Assessment of Pacific Gas & Electric Company's Pipeline Safety Enhancement Plan

Prepared For
Consumer Protection & Safety Division

December 23, 2011

Figure 5 - PG&E Program Management Organization Structure

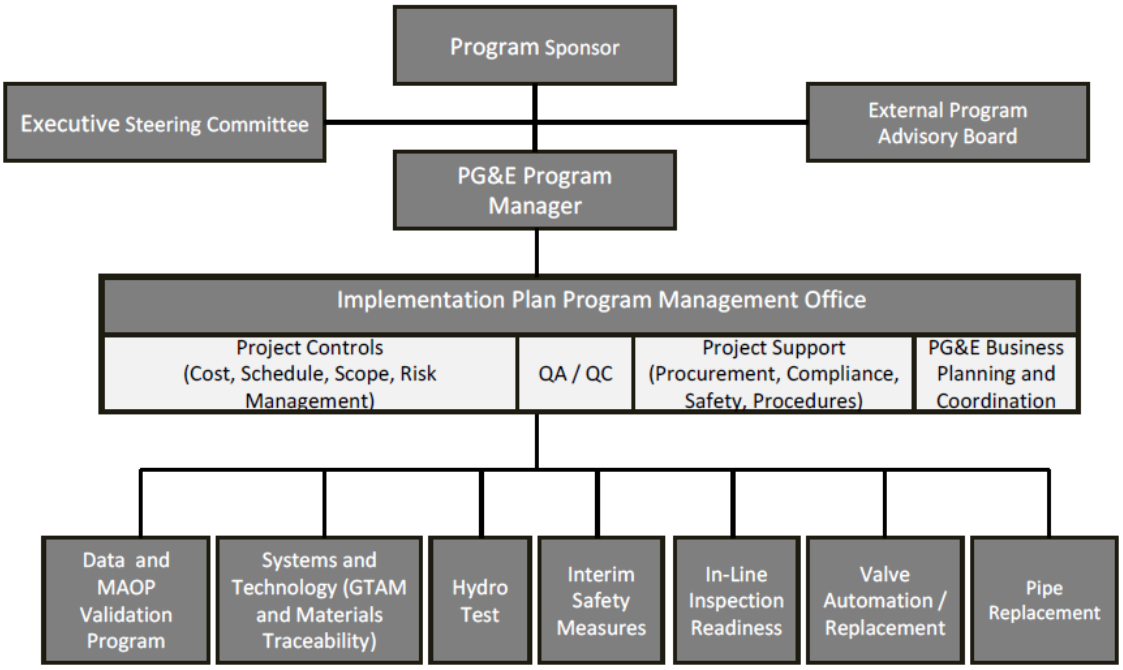
While the specific structure of a program management organization can somewhat vary based on a given program's size, complexity, and client needs, the PG&E program management organization structure, as shown in Figure 2, is consistent with industry practices, as are the roles and responsibilities of the major functions. The major functions of PG&E's programs management organization are:

- The Implementation Plan PMO organizational structure looks to provide a good framework. The organization and governance is based on current industry practices.
